SECTION 00 9112
ADDENDUM NUMBER 2

DATE: 03/02/2021
PROJECT: CITY OF MILLERSBURG FIRE STATION 15
ARCHITECT'S PROJECT NUMBER: 20006
OWNER: CITY OF MILLERSBURG
ARCHITECT: SODERSTROM ARCHITECTS

8 HM DOOR FRAME
6" = 1'-0"

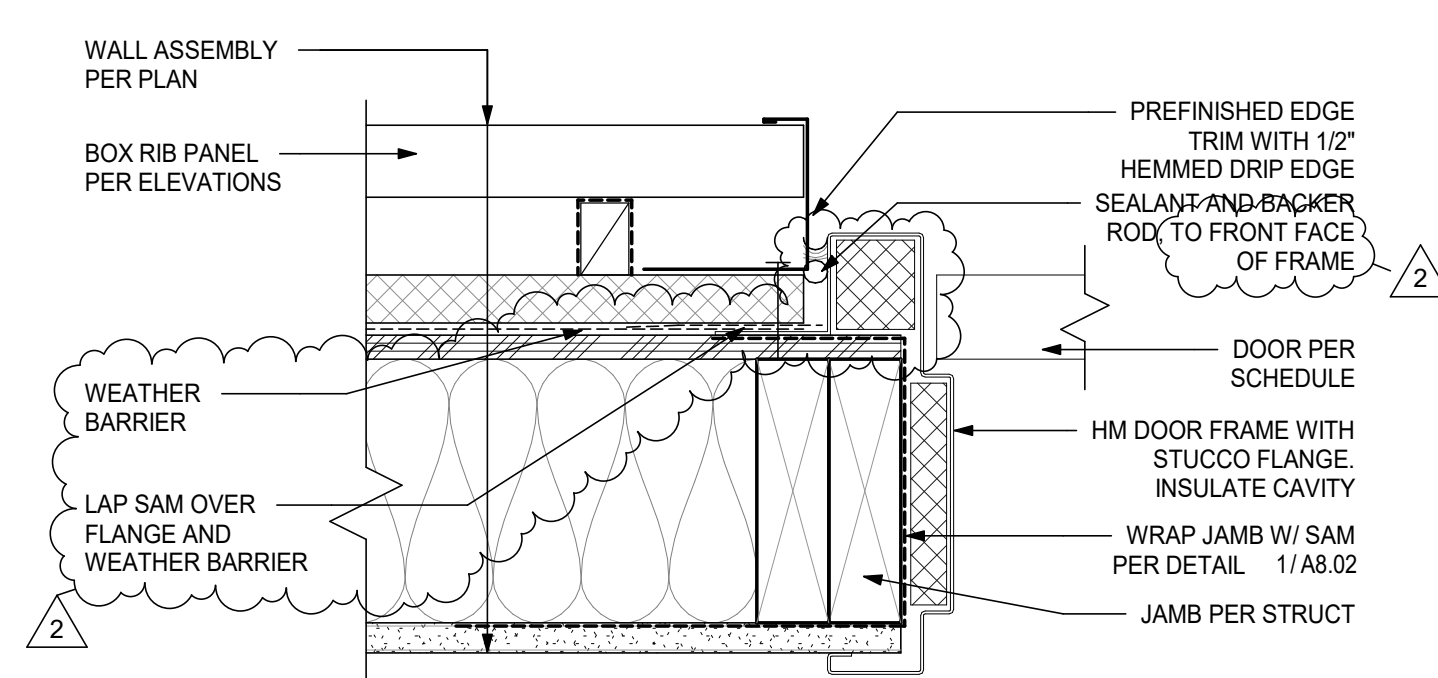
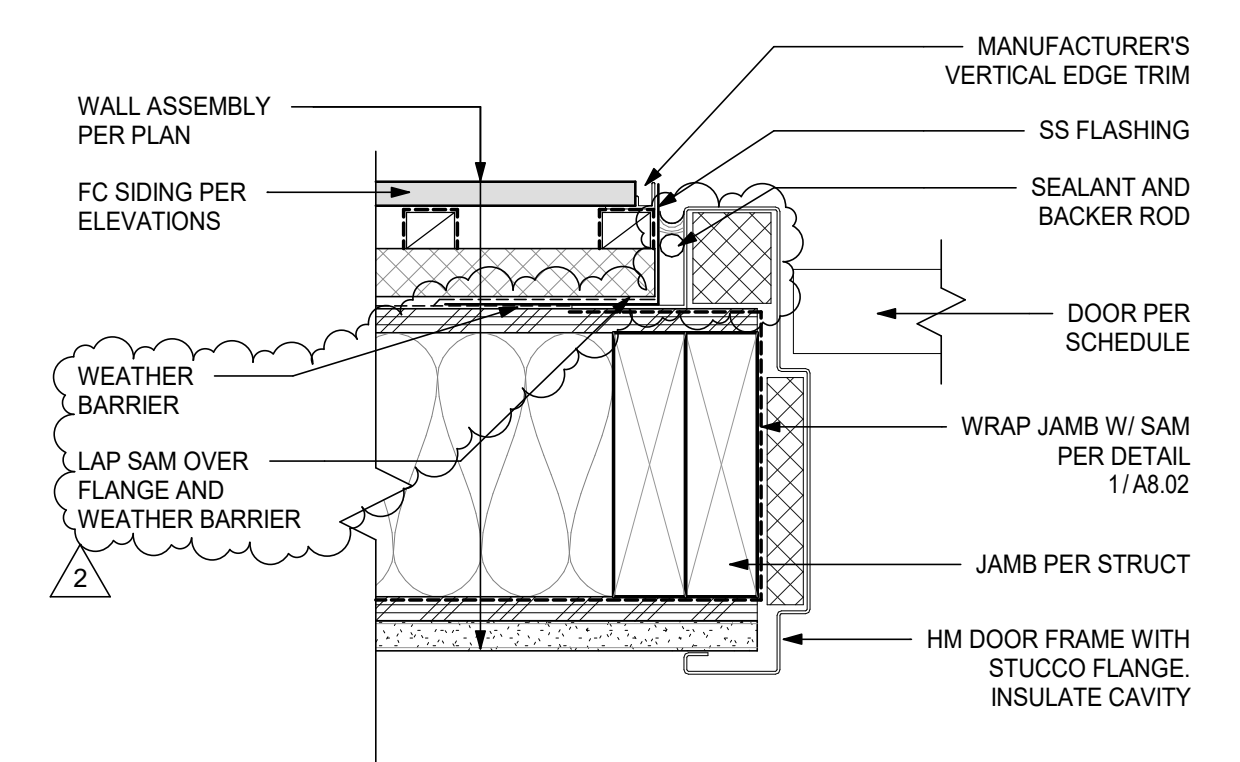
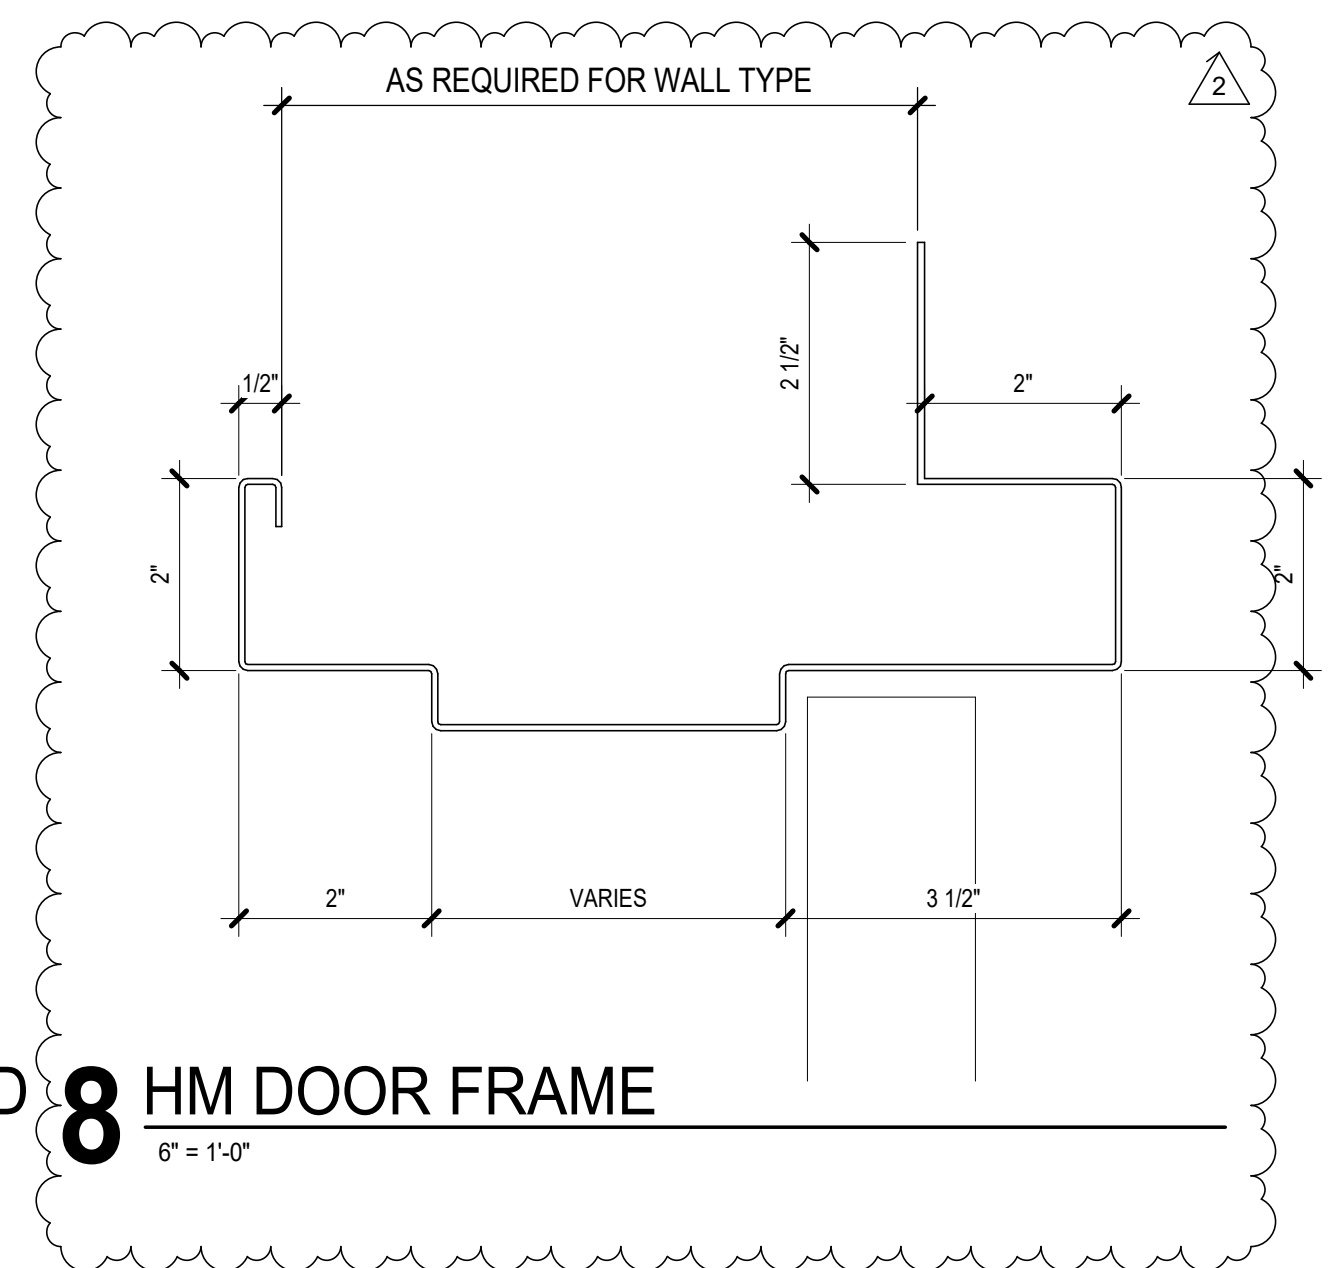
DRAWING 8/A8.12

Added New detail 8 – Hollow Metal frame profile

Revise Details 6 and 7 to indicate revised frame configuration and sealing

17. **"Standard" 1/2" return of frame to wall shown for interior frames. Exterior HM frames shown details 2, 3, 6, 7/A8.12 appear to have different frame return margin on exterior face. Please provide dimensioned detail for Exterior HM frame profiles. Ext. frames appear to be custom profile.**

- A. Provide gypsum board at top of wall.
- 69. Exterior sealant joint shown to bridge gap between HM frame and edge of 1" insulation board. Sealant will not adhere to exposed edge of insulation board. Detail 7 shows a SS flashing flange secured behind the insulation board creating a metal surface for the sealant to adhere to. This will work. Please clarify detail 6/A8.12.**

A. See added detail 8/A8.12 for profile, and updated Specification Section 08 113 re-issued with this addendum.

- A. Details 6 and 7 have been revised with modified HM frame profile. See revise A8.12 issued with this addendum.
- 70. Recommend the pipe penetrations have a self adhered flashing rather than a sealant at the sheathing. Please confirm.**
